August 14, 2017

California Air Resources Board  
Anil Prabhu  
aprabhu@arb.ca.gov  
LCFSWorkshop@arb.ca.gov

Reference: **Comments on Corn Oil Biodiesel Carbon Intensity**

**Figure 1.** Corn Ethanol System Boundary Diagram

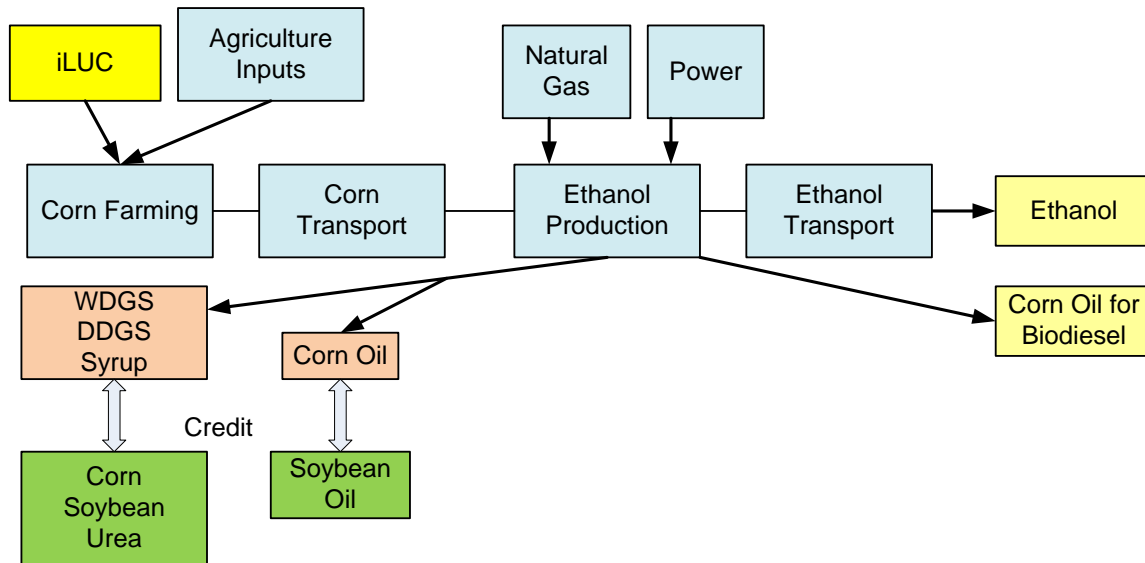
- Provide substitution credit for corn oil used as animal feed based on soy bean oil\
  - Corn oil is a substitute for soy oil in animal feed and the same upstream and ILUC emissions should be the basis for the co-product credit.
- Allocate energy inputs and emissions between ethanol and corn oil used for biodiesel based on energy content of product
  - Both ethanol and corn oil for COB are energy products and the burden of the emissions should be distributed to both products based on energy.
- Allocate ILUC to ethanol and corn oil for COB based on energy content of products
- Track carbon intensity in g/kg or g/lb of corn oil
  - Allows for GREET-type inputs for COB pathway

The current corn ethanol pathway assigns all of the corn oil (CO) production as a part of DGS and gives credit based on the same displacement ratios as DGS. CO is used in animal feed as a direct substitute for soy oil and hence should be provided with a 1:1 displacement credit for soy oil. This implies that the amount of corn oil produced will no longer be included in the DGS amount, slightly reducing the DGS credit but increasing the amount of credit for CO.

Additionally, the corn oil used for BD production should be treated like an energy product. Therefore, similar to other pathways in CA\_GREET, CO, as energy co-product, should be allocated all the energy inputs and the corresponding emissions based on the energy allocation method. Per the energy allocation method, the emissions are allocated to various products proportional to the total energy content of each of the respective co-product produced. This approach also implies that the corn oil does not receive a displacement credit. The CI of this CO is also associated with it and is carried over to the BD producer who essentially buys this CO along with its associated CI burden. ARB may choose to assign an average CI value for this to every COB producers for accounting simplicity.
